**Public Hearing
CITY OF AUSTIN
RECOMMENDATION FOR COUNCIL ACTION**

SUBJECT: Consider action on an appeal Ed King (Long Canyon Home Owners Association, Phase I) and Joseph Konopka (Long Canyon Home Owners Association, Phase II/III) of the Zoning and Platting Commission's decision to grant a Hill Country Roadway Site Plan with waiver/variances for Potter's Dentistry at 7901 FM 2222 (site plan no. SPC-04-0022A).

POTTER'S DENTISTRY SITE PLAN APPEAL

ZONING & PLATTING COMMISSION SITE PLAN HILL COUNTRY SITE PLAN REVIEW SHEET

1" = 400'	SUBJECT TRACT 	SITE PLAN CONSOLIDATED CASE #: SPC-04-0022A ADDRESS: FM 2222 NORTH OF BELL MOUNTAIN DR SUBJECT AREA (acres): 4.724		CITY GRID REFERENCE NUMBER F31
	PENDING CASE 			
	ZONING BOUNDARY 	DATE: 04-12		
	CASE MGR: S. WELCH	INTLS: SM

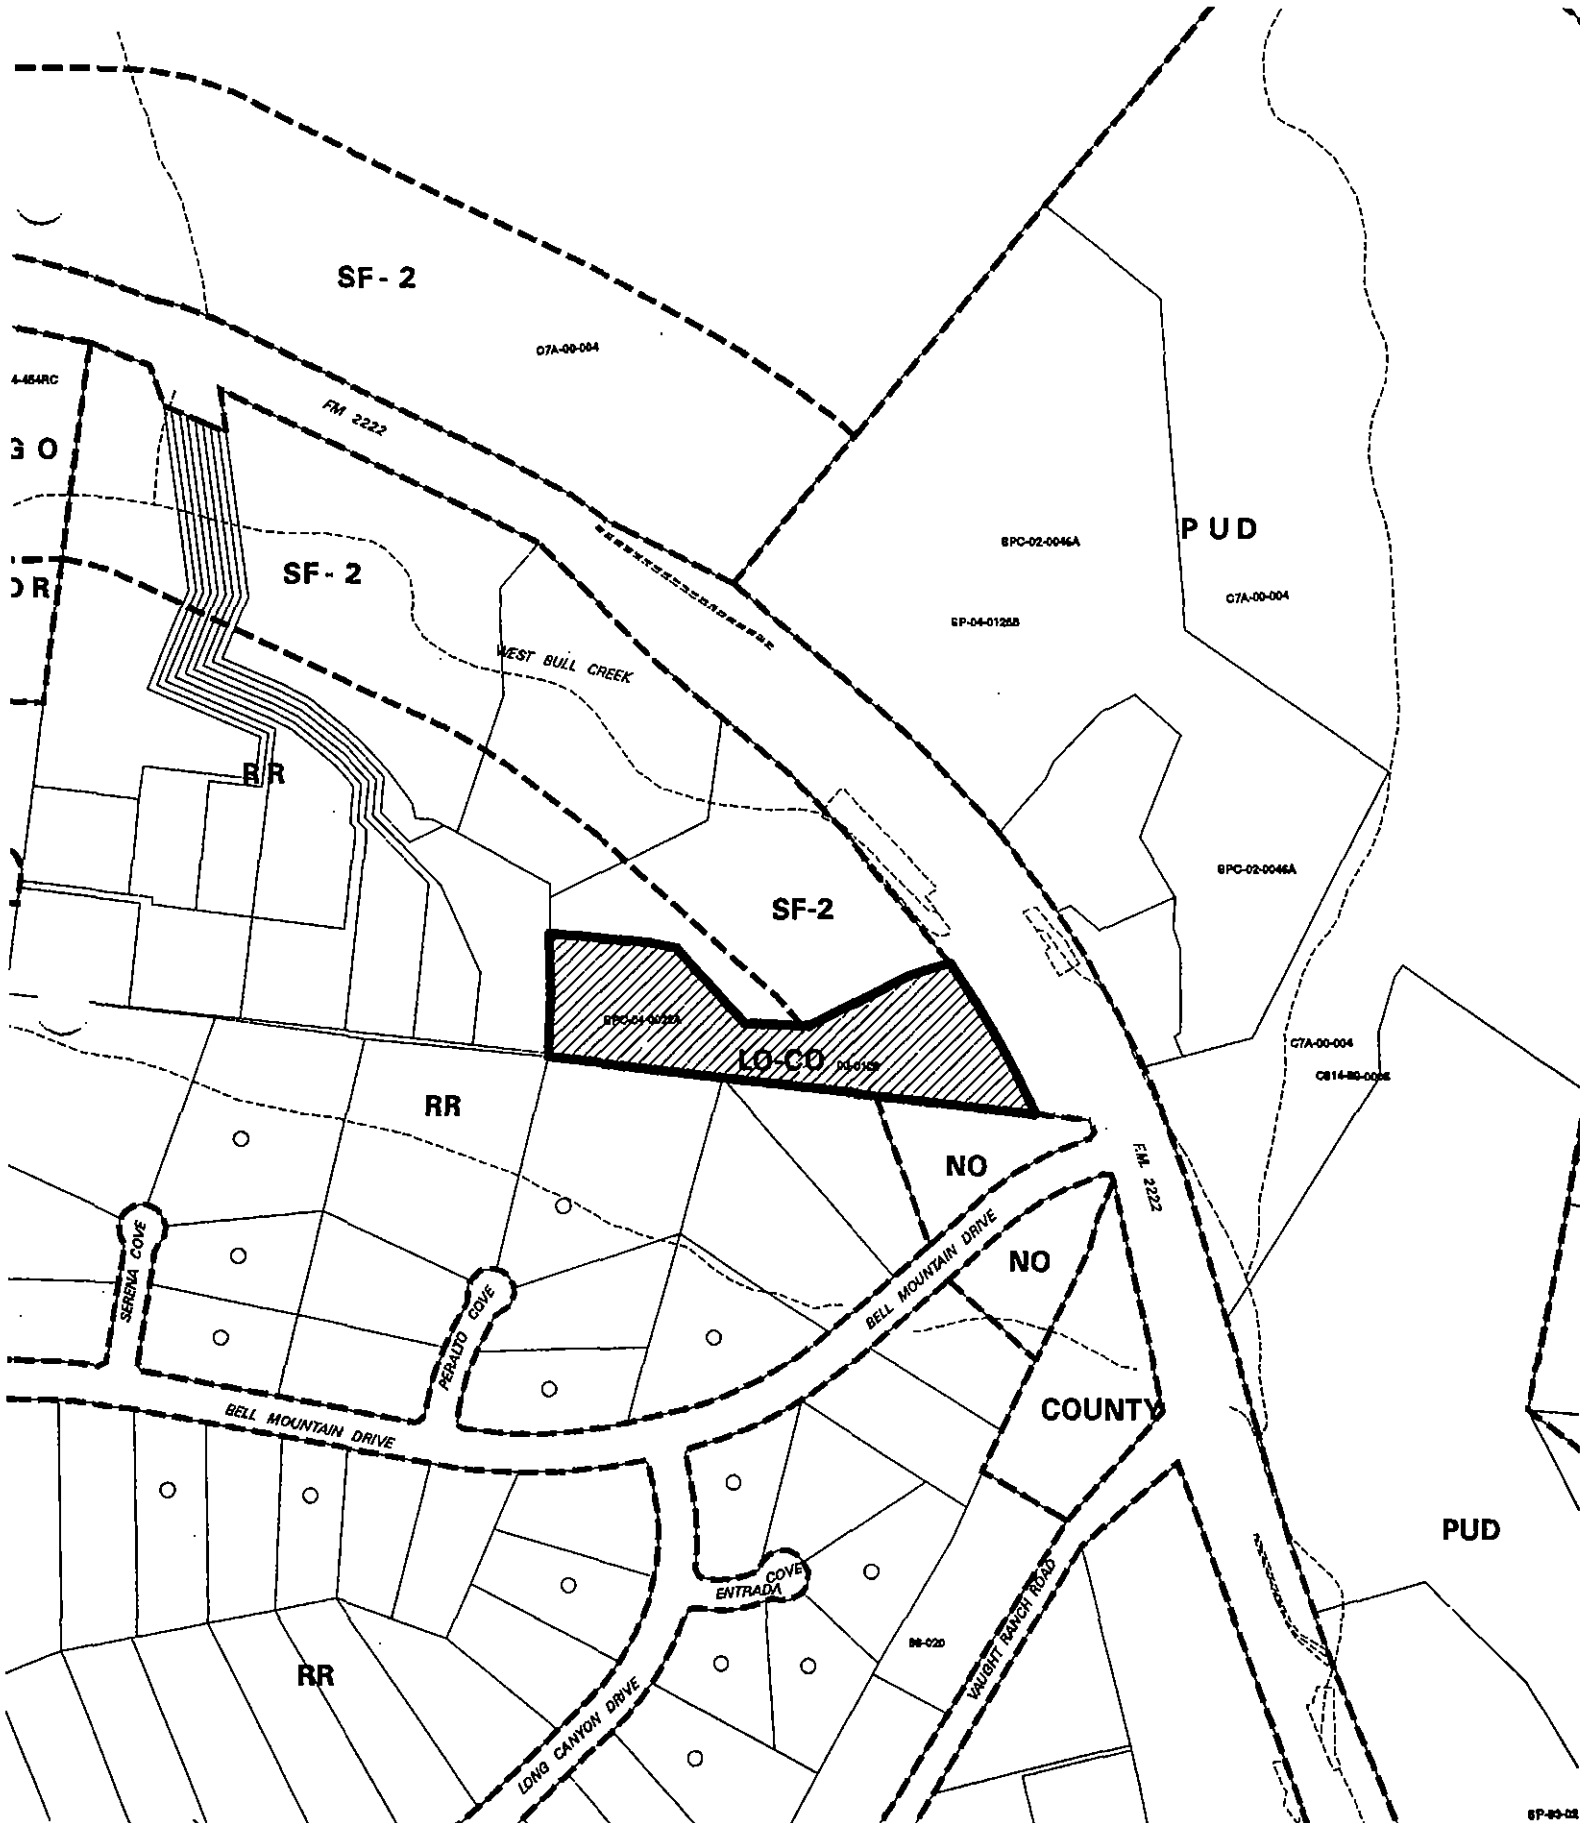
SUMMARY COMMENTS ON SITE PLAN:

Transportation: Access will be taken from FM 2222, and TxDOT has approved the proposed driveway. The estimated trip generation for this use complies with the zoning conditions for less than 2,000 vehicle trips per day. This site plan complies with all other transportation requirements.

4.724 ACRES OF LAND, A PORTION OF
 THE HRS. WM. L. SWAIN SURVEY NO. 810, ABSTRACT NO. 727,
 CITY OF AUSTIN, TRAVIS COUNTY, TEXAS

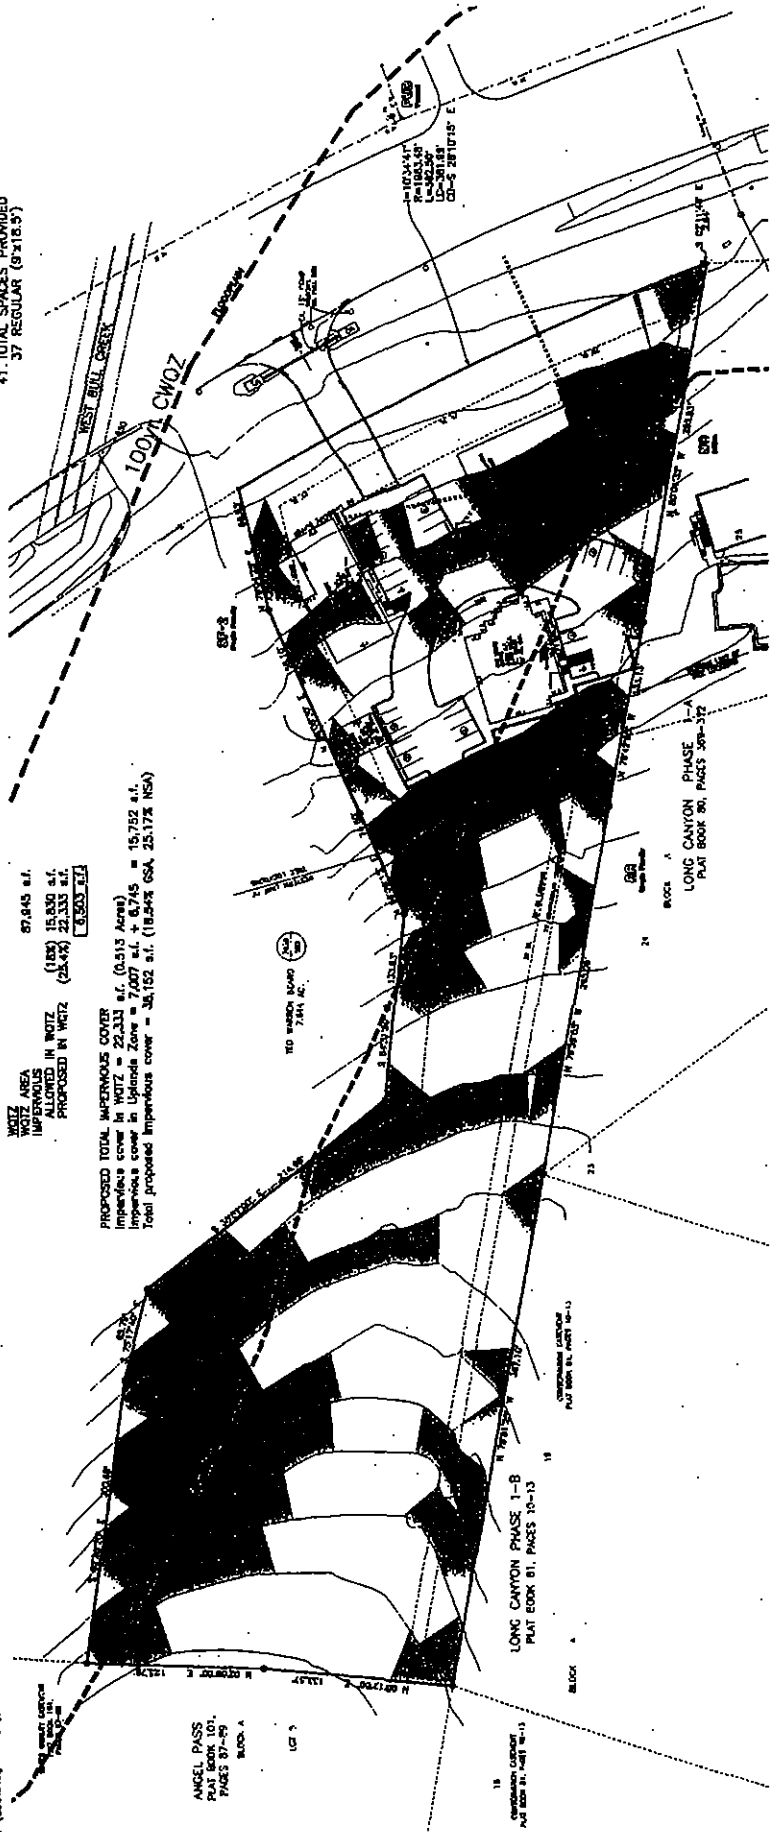
Existing Impervious Cover 13,651 s.f.
 Proposed Impervious Cover 8,272 s.f. (1,022 G.S.A. 5,652 N.S.A.)
 Buildings 21,135 s.f.
 Pavement 28,407 s.f.
 Total 49,542 s.f.
 Roadway Impact 8,745 s.f.
 Percent Impervious 18.54% (GSA) 25.17% (NSA)
 Total gross site area = 262,787 s.f.
 Site Deductions Critical Water Quality Zone (CWQZ) = 0.00 Acres
 Water Quality Transition Zone (WQTZ) = 87,845 S.F.
 Wetland/riparian area = 0.00 Acres
 Deduction subtotal = 87,845 S.F.
 Upland area (Gross area minus total deductions) = 174,942 s.f.
 Net Site Area Calculations
 Area of Uplands with Slopes 0-15% 119,075 X 100% = 119,075 s.f.
 Area of Uplands with Slopes 15-25% 76,850 X 40% = 30,740 s.f.
 Area of Uplands with Slopes 25-35% 8,489 X 20% = 1,698 s.f.
 Net Site Area (subtotal) = 151,513 s.f.

PROPOSED TOTAL IMPERVIOUS COVER
 Imperious cover in WQTZ 22,335 s.f. (0.513 Acres)
 Imperious cover in Upland Zone 15,830 s.f. (0.361 Acres) = 15,752 s.f.
 Total proposed impervious cover = 38,162 s.f. (0.874 GSA, 25.17% NSA)

Final Site Plan. Reduced To Two Buildings
Reduced Square Footage.
SPC-04-0022A

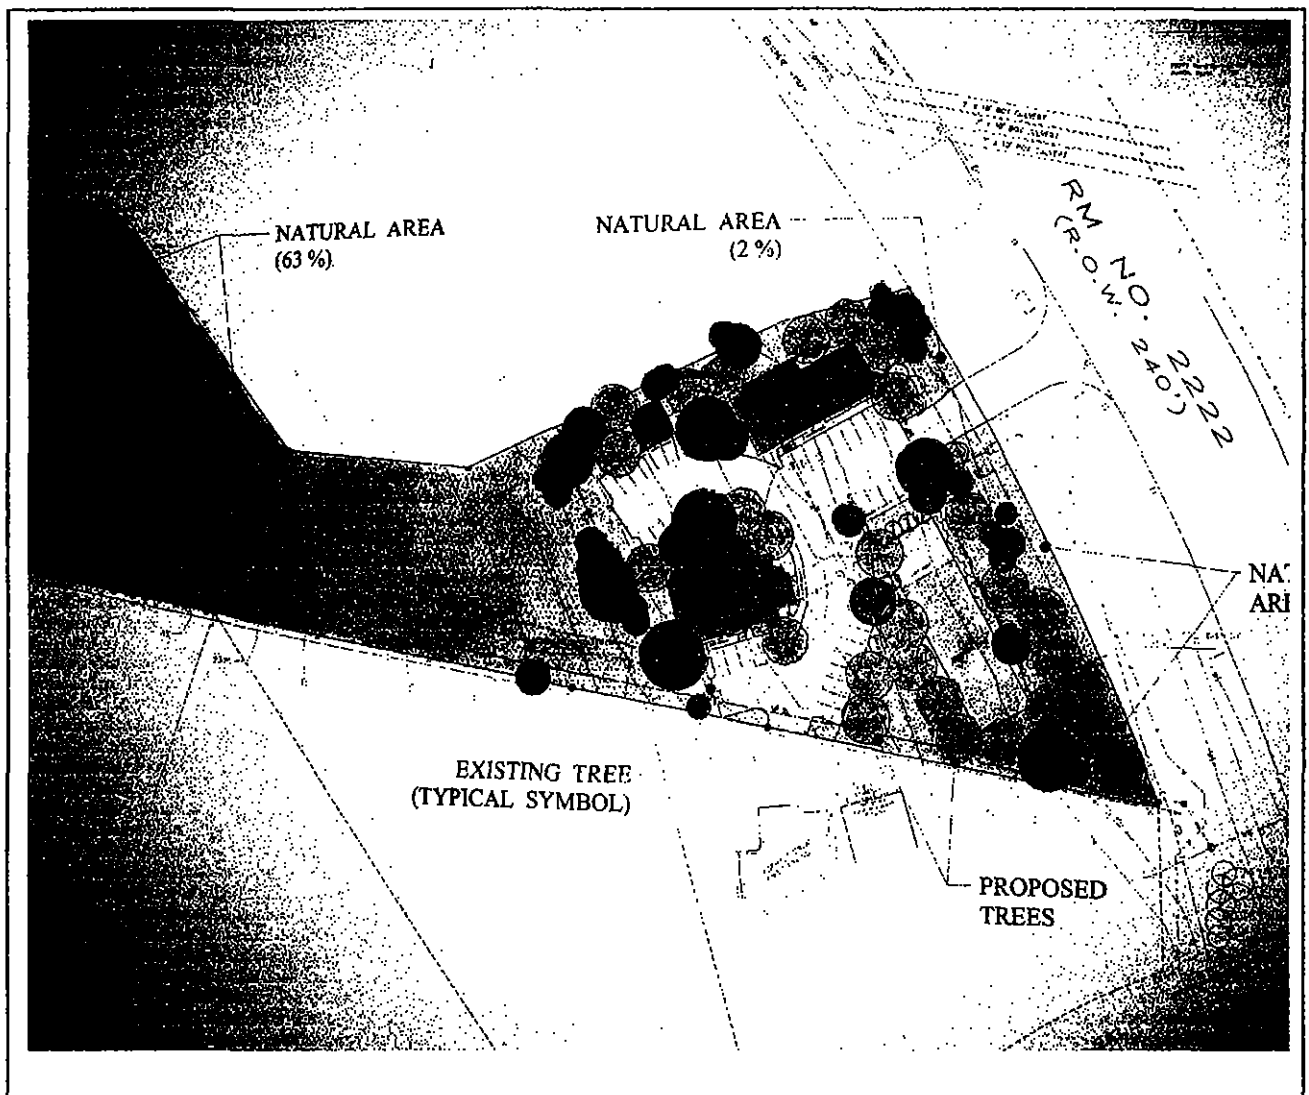
Attached for your review are 29 letters of support for Site Plan SPC-04-0022A, Potter Dentistry. Each letter was obtained after meeting one-on-one with the endorsing party and discussing the project. Included with the letters are three documents that show the location and site plan (titled "Project Location", "Original Site Plan: Three Buildings", and "Final Site Plan: Reduced to Two Buildings").
